1822 Bank Street

URBAN DESIGN BRIEF - R3

April 3, 2025

RESPONSE TO URBAN DESIGN COMMENTS

RELATIONSHIP TO ADJACENT NEIGHBOURHOODS

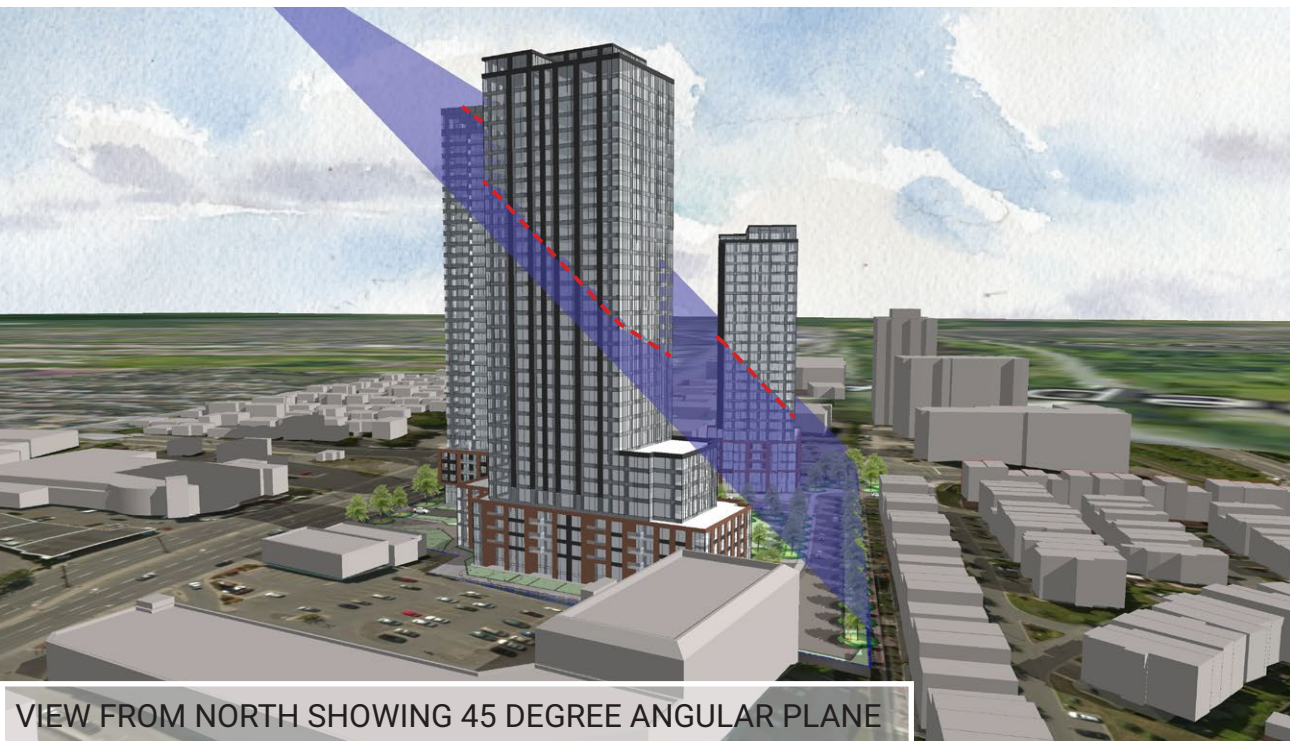
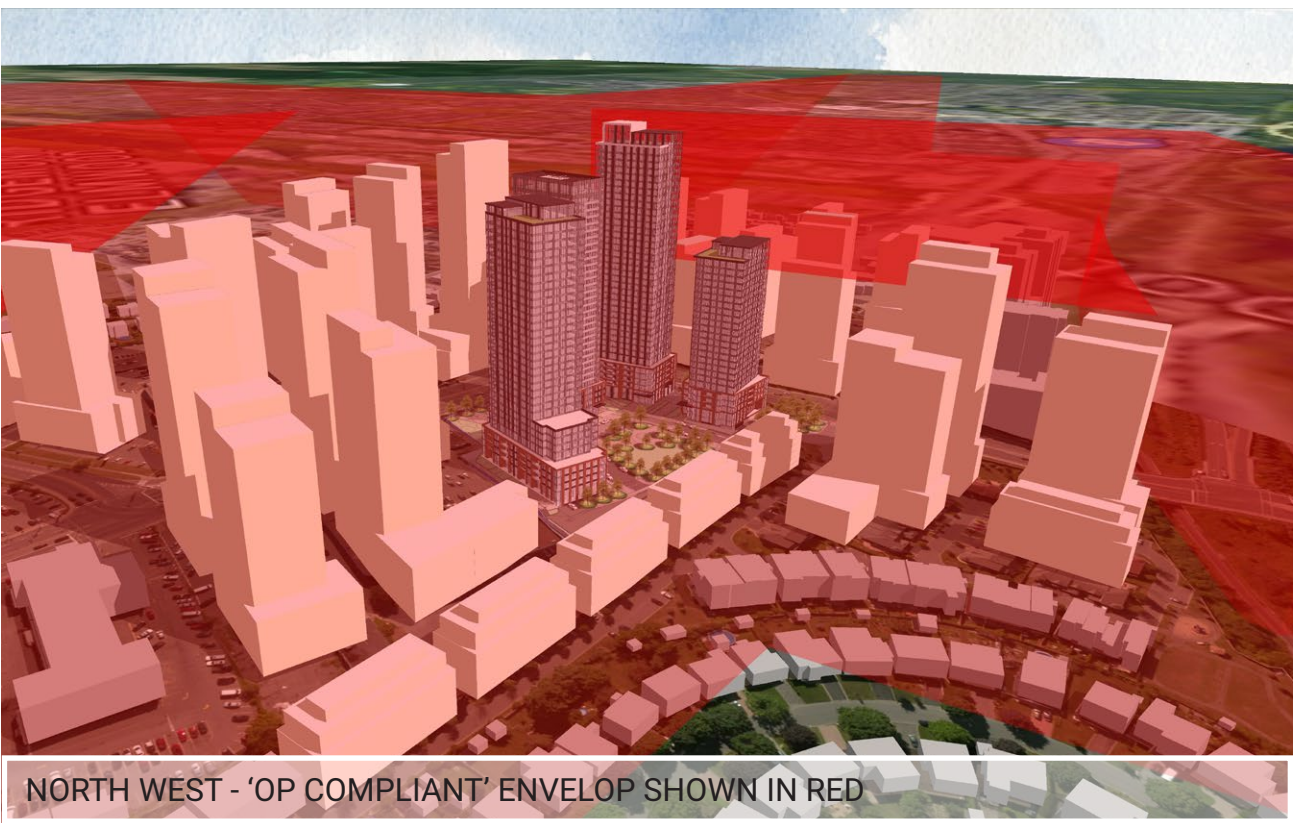
17. Towers 1 and 4 protrude significantly above the 45-degree angular planes as shown on page 20 of the submitted Design Package.

ii. Tower 4 – The height should be reduced. It is interesting to note that if Tower 4 is a 16-storey building, permitted by the Secondary Plan, it will not protrude above the angular plane.

28. Slide 20 of the Design Package demonstrates the buildings projecting above the angular plane. While the angular plane is not meant to be a rigid determination of heights, it does inform the general appropriateness of building heights. In this case, it seems to me that Building 4 should be reduced by several storeys. In addition to improving the building height transition, this would add more variation to the building heights.

Applicant: We acknowledge that towers 1 and 4 protrude through the angular plane. However we feel that this massing response is reason given the significant adjacent open space gained by locating the park at the west side of the property closest to adjacent low-rise. The park location serves to balance the impacts of the taller building forms. Additional, building 1 is the closest of the buildings to the new transit station, and therefore an appropriate location for a taller / higher density form.

Applicant: See comment 17 above.

FUTURE DEVELOPMENT POTENTIAL

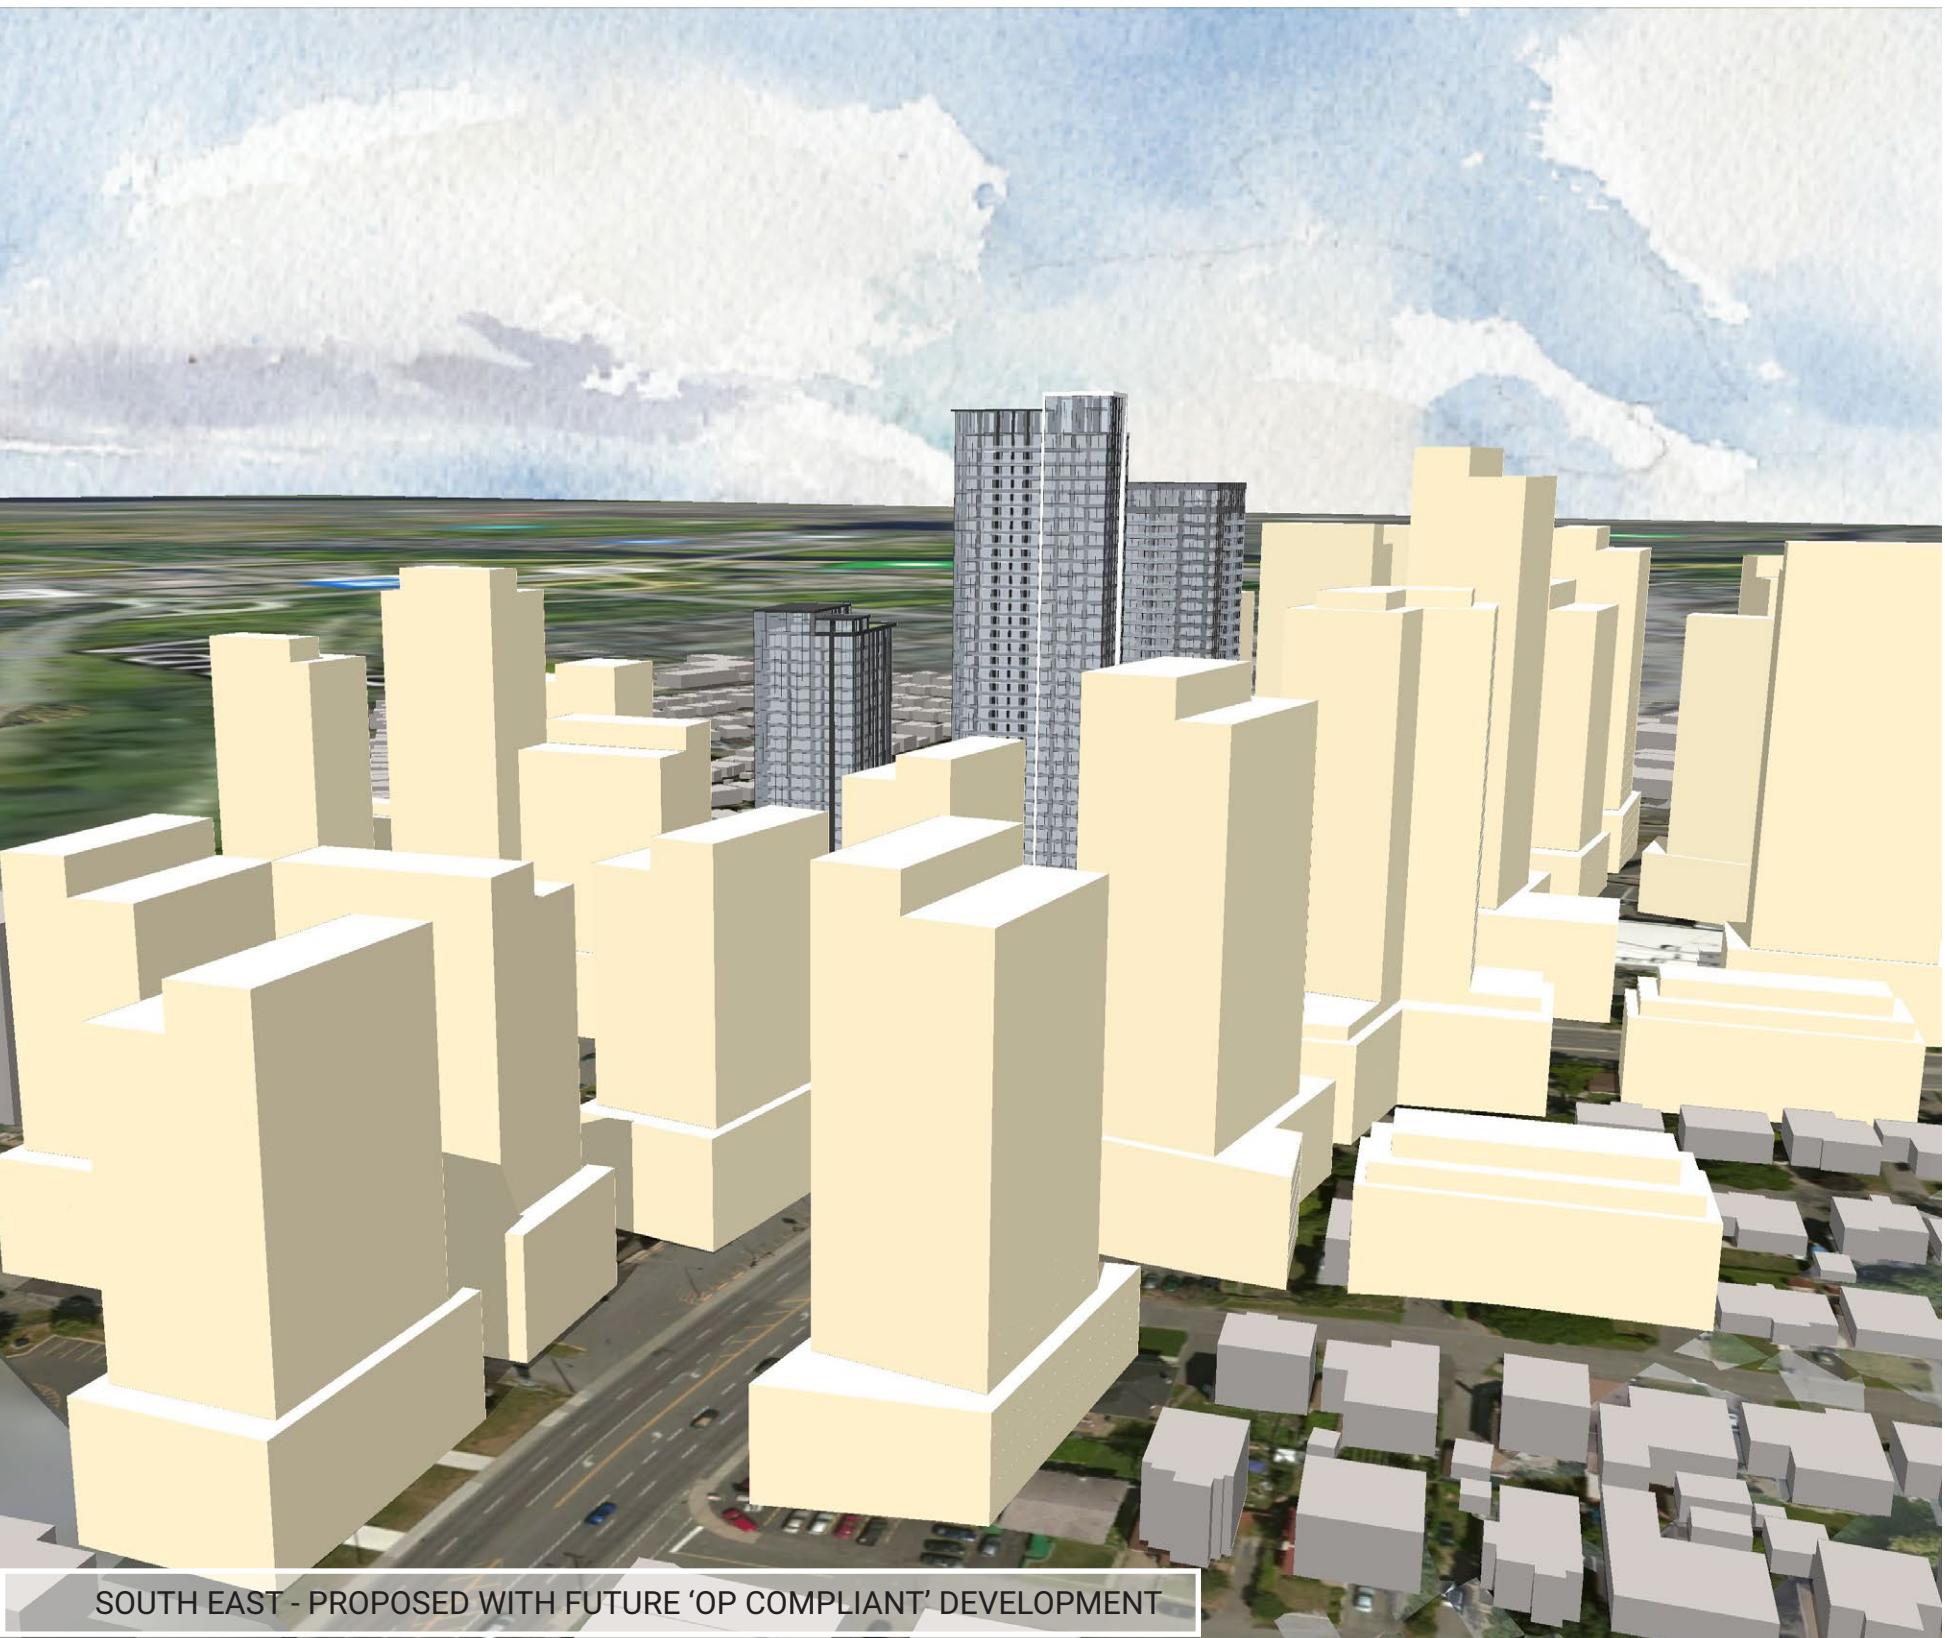
37. It is crucially important to explore and study block plan for the northwest quadrant of Bank and Walkley following directions of the Secondary Plan. A realistic block plan can offer clarity and provide guidance to the design of this site, including street and pathway connections, provision of parks and open spaces, and managing

Applicant: In the UDRP submission deck we have included 'Future Development Potential' massing studies that look at how the blocks to the north may be developed out under the new OP frames and in a pattern that contemplates the extension a street northward to Alta Vista Drive.

Applicant: Images on Pages 21 and 22 (Pages 35-36 on the updated Urban Design Brief) were provided at the request of City of Ottawa Planning staff. They illustrate the proposal in the concept of future development potential as recognized by the Official Plan at a point sometime in the future.
